Re: Product Change Notification for Harwin product.

Product in the C90-3106F range has been subject to dimensional changes relating to the supplied rubber bushing.

RUBBER BUSHING

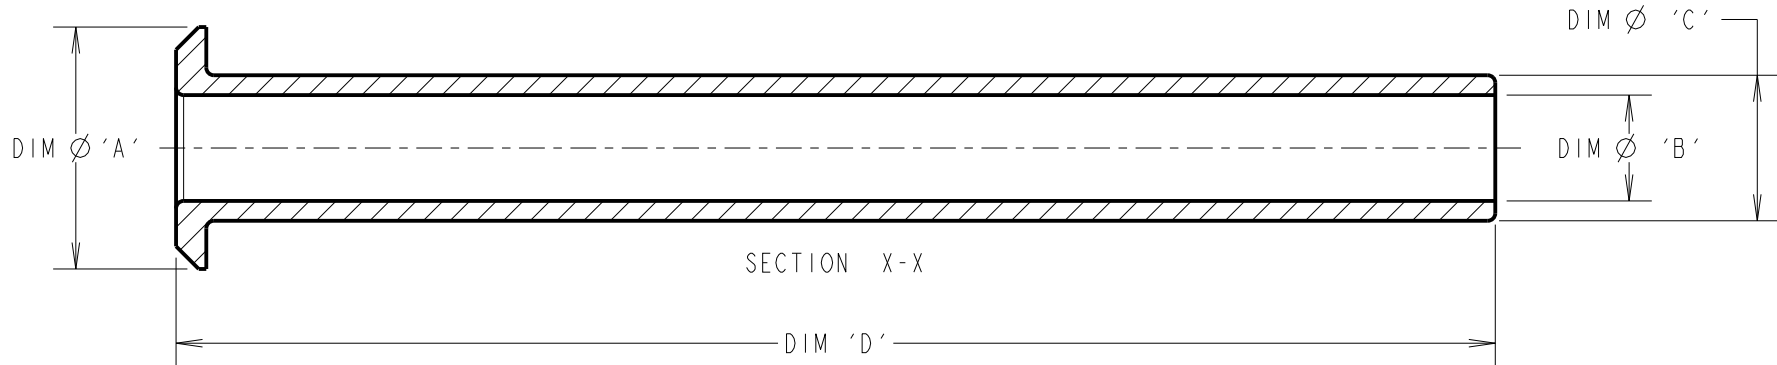
This change was actioned during Q4 2021 – no PCN was triggered or released at this time, so you may have already received stock to the new design. The change was to the size of the inner bore of the bushing.

Inner bore diameter	Supplied Rubber Bushing (also available separately)
Before the change in Q4 2021	6.60mm nominal	C90-3420-5
After the change in Q4 2021	5.60mm nominal	C90-3420-4

If you require the larger bore rubber bushing, please order the C90-3420-5 as a separate component.
